From: Julie Haerland
Sent: 26/06/2024 1:37:17 PM
To: Council Northernbeaches Mailbox
Cc: Bob Vinks; Stef Vinks
Subject: TRIMMED: Objection- 25 Valley Road, Balgowlah Heights DA2024/0633
Attachments: 11am June 21.pdf; 12noon June 21.pdf; 10am June 21.pdf; 9am June 21.pdf; Objection Letter- 25 Valley Road Balgowlah Heights.pdf; SERVICE PROTECTION REPORT.pdf;

Re- DA 2024/0633- 25 Valley Road, Balgowlah Heights

SERVICE PROTECTION REPORT
18 CONDAMINE STREET
BALGOWLAH 2093

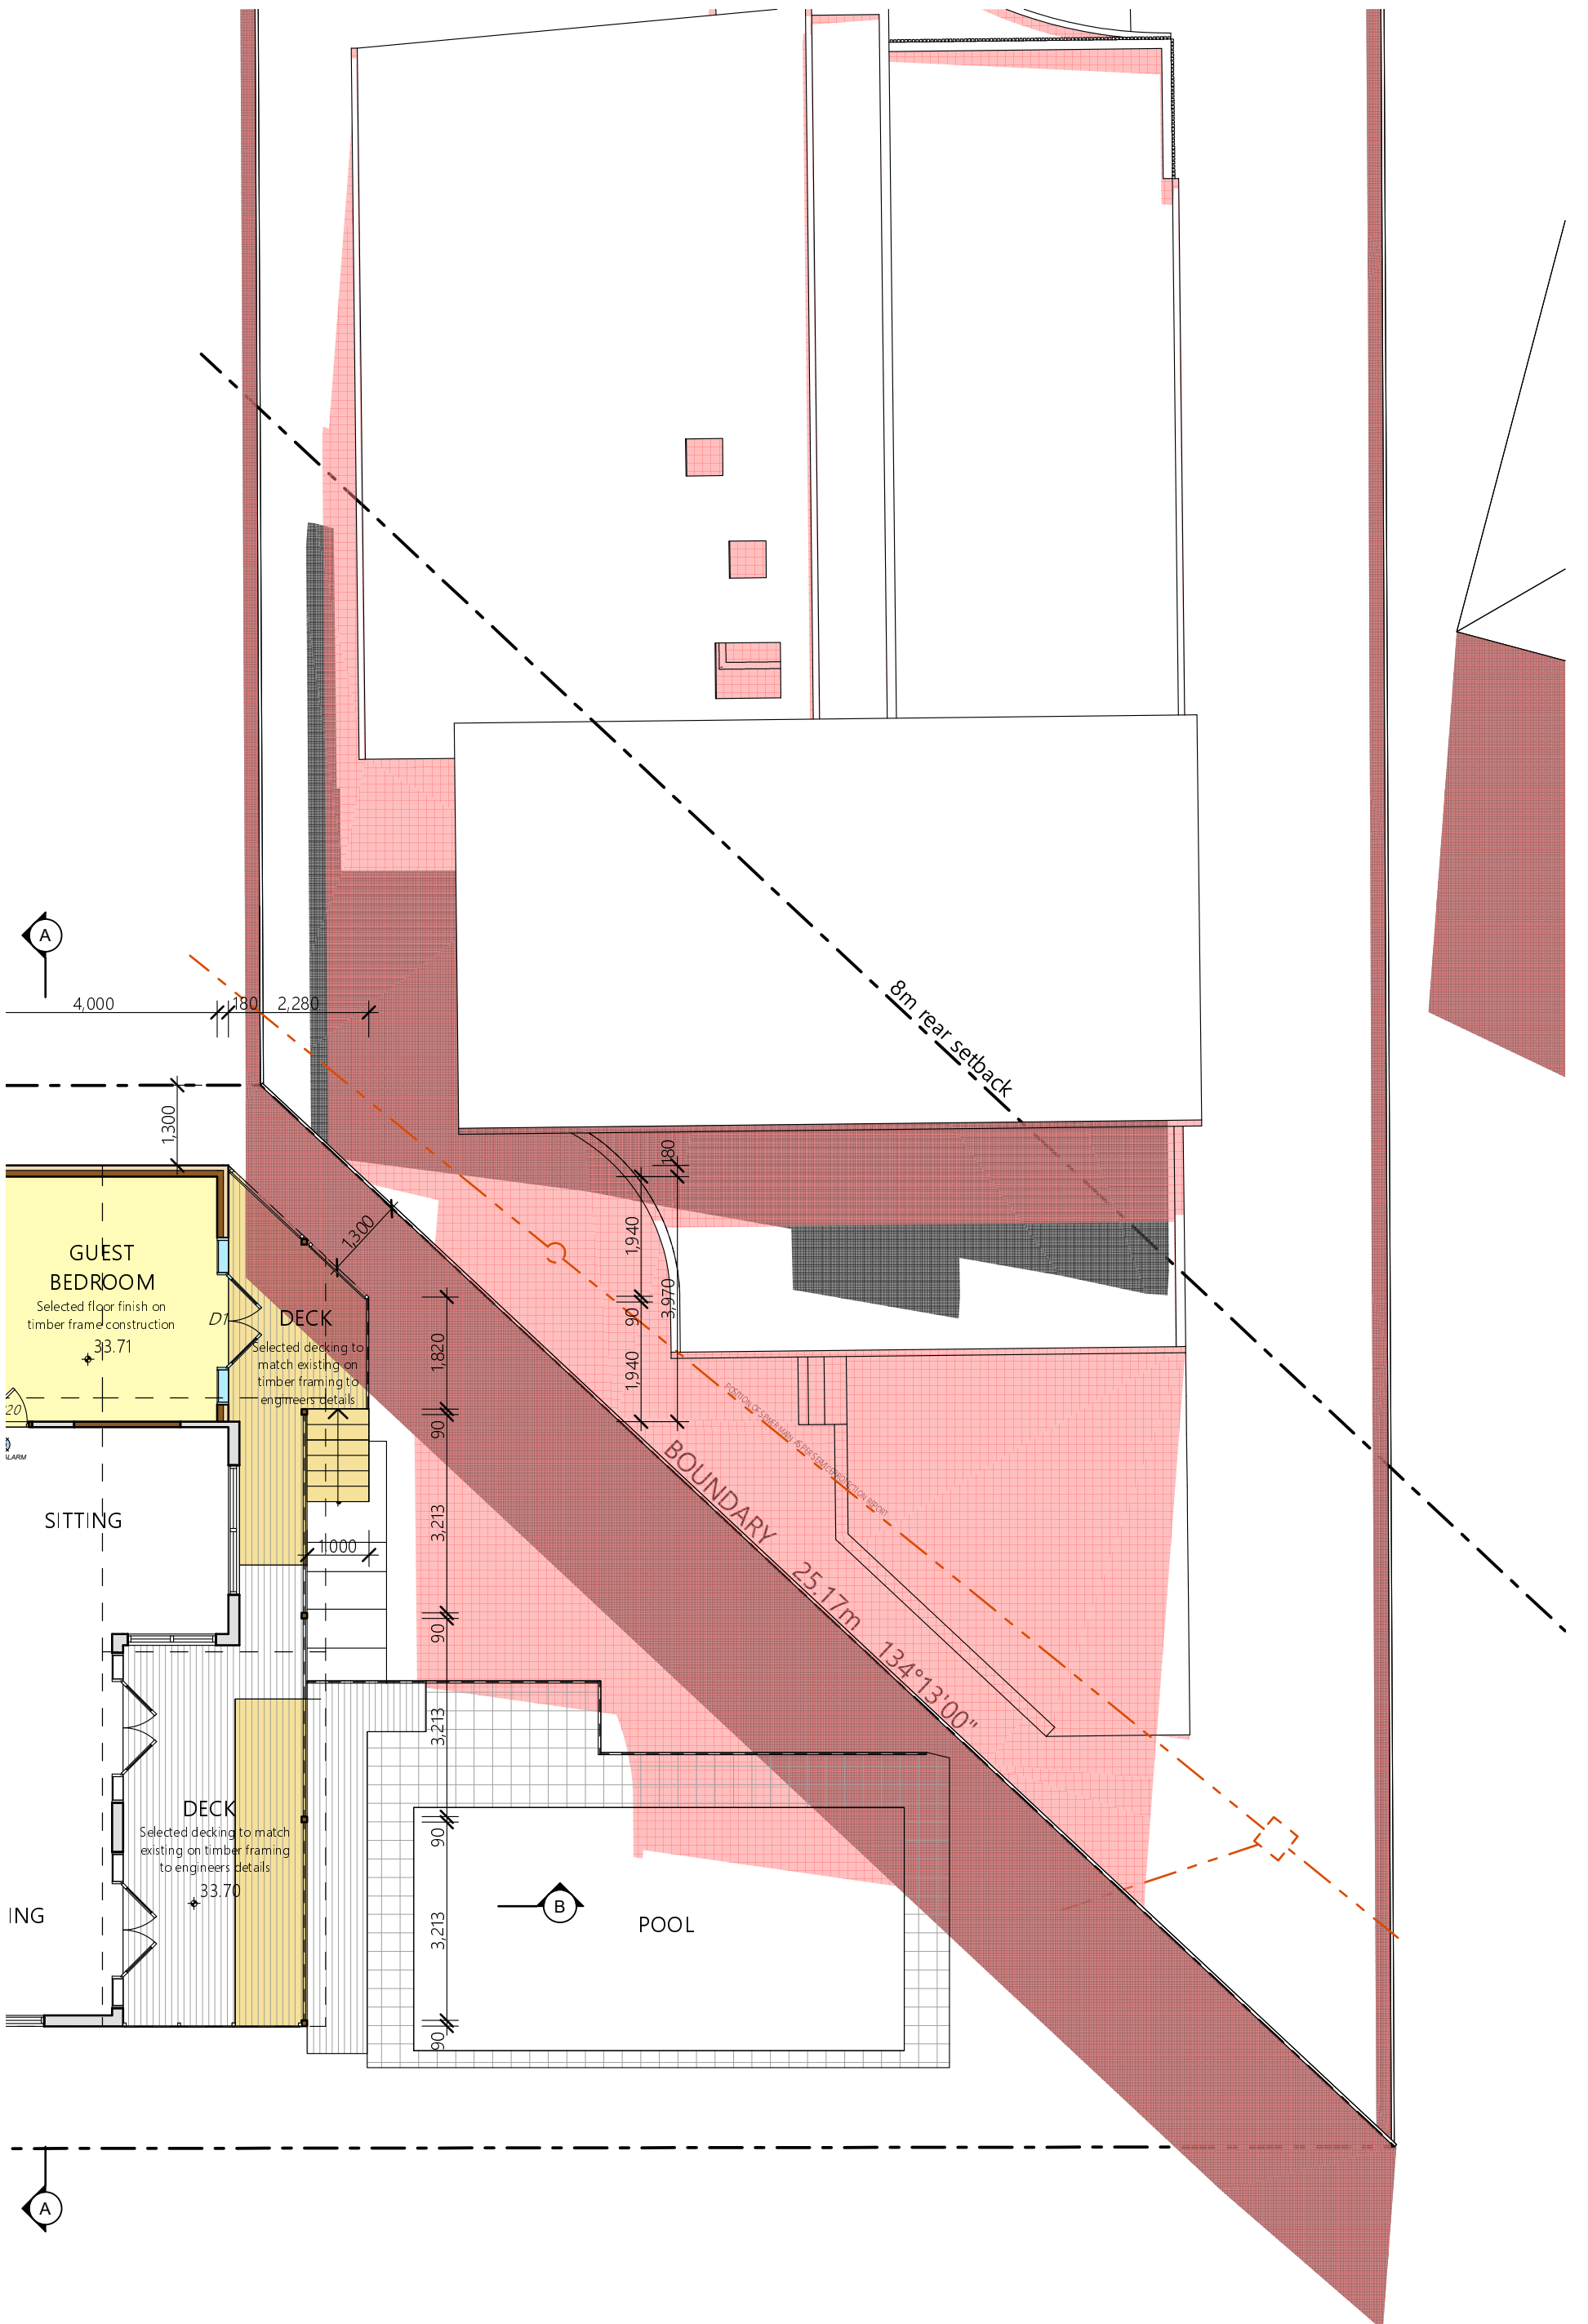
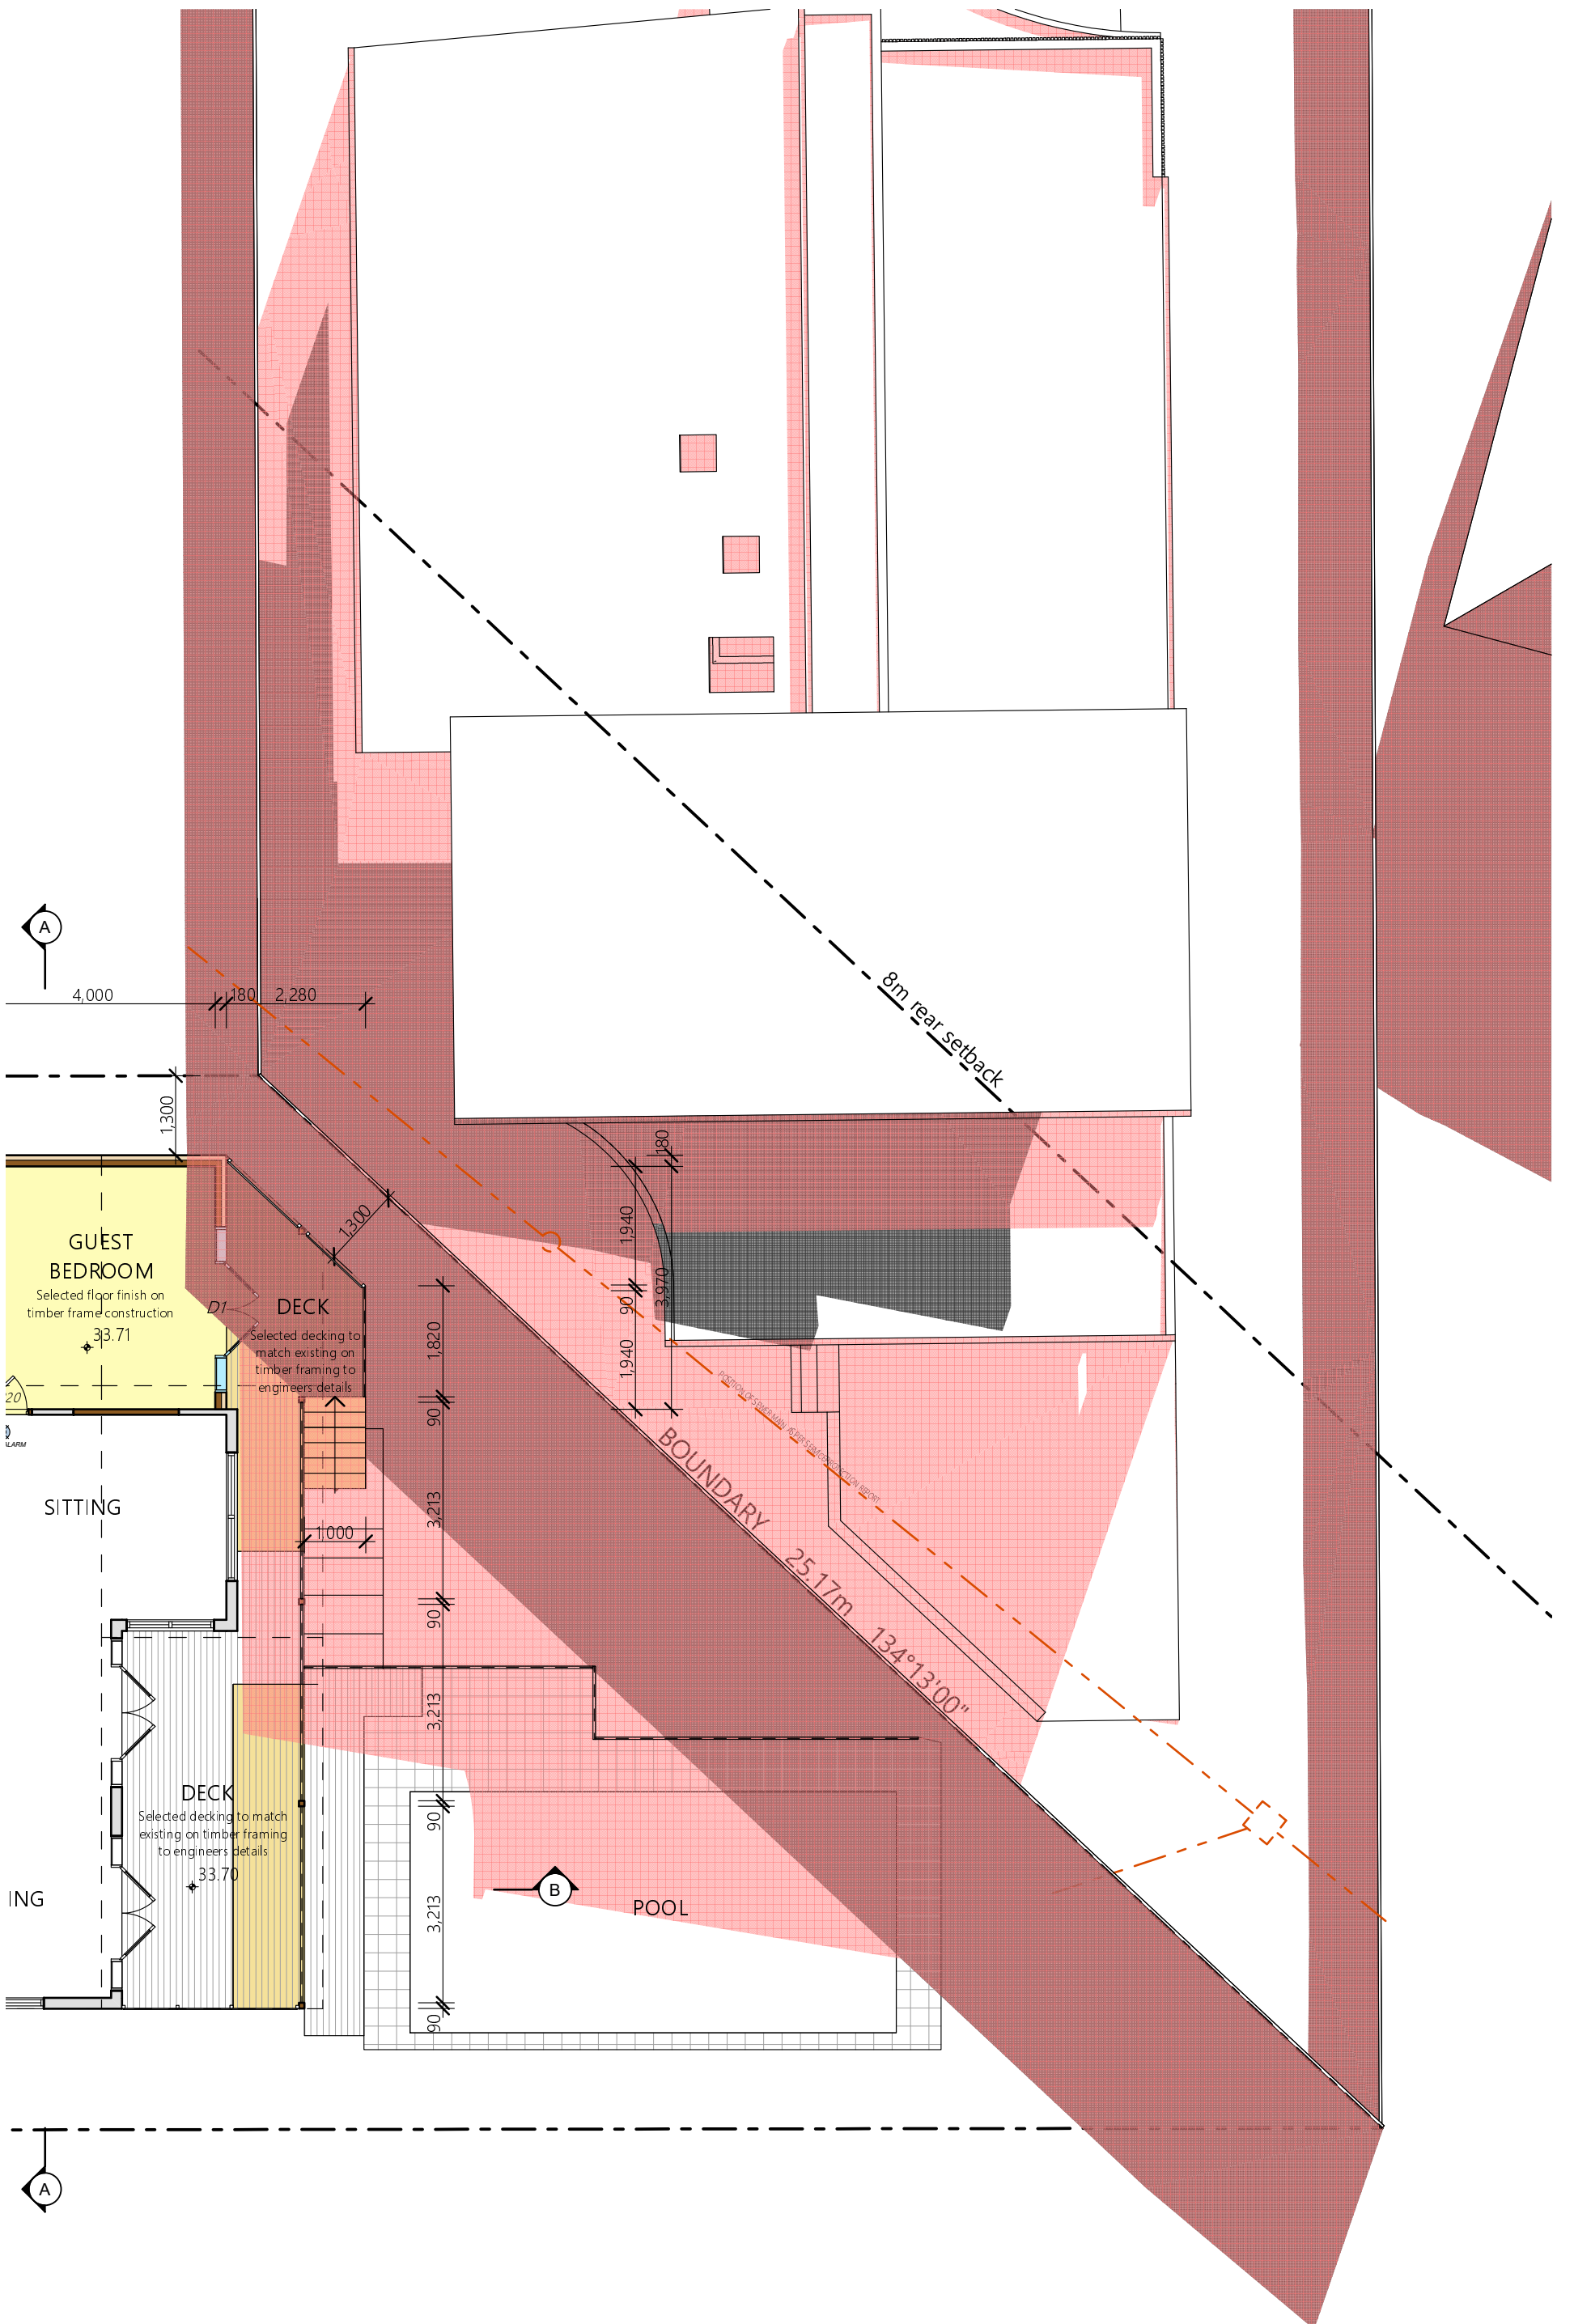
The proposed additions at 25 Valley Road come right up to the rear boundary and will completely overlook the private open space and swimming pool of 18 Condamine Street. The structure will create an extensive amount of additional overshadowing. We have provided shadow diagrams that now show the relationship of 18 Condamine Street to the proposed alterations at 25 Valley Road. As you can see the rear yard, deck and pool will almost be completely shaded from 9am right through to 12 noon. This will drastically reduce the amount of lovely northern light on the entire area of principal open space of 18 Condamine Street. The DCP states: *“New development (including alterations and additions) must not eliminate more than one third of the existing sunlight accessing the private open space of adjacent properties from 9am to 3pm at the winter solstice (21 June)”*. The proposal clearly takes away half of the existing sunlight and as such does not comply with aims and objectives of the DCP.

Furthermore, it is noted that as part of the recent Council approval on 18 Condamine Street, the Boards sewer was pegged out (see attached). This pipe is shown on the shadow diagrams attached to this objection letter. The proposed alterations and additions at 25 Valley Road will impede this pipe. In fact, we would suggest that Sydney Water approval would not be given for the structures proposed.

- Greatly increased rear boundary setbacks to provide additional privacy and reduced overshadowing of 18 Condamine Street
- Privacy measures to the rear alfresco- moving it further to the east and north.
- Strict adherence to the 55% soft landscaping
- Any hedging proposed along the rear boundary to reach a maturity of 2m maximum from ground level of 25 Valley Road
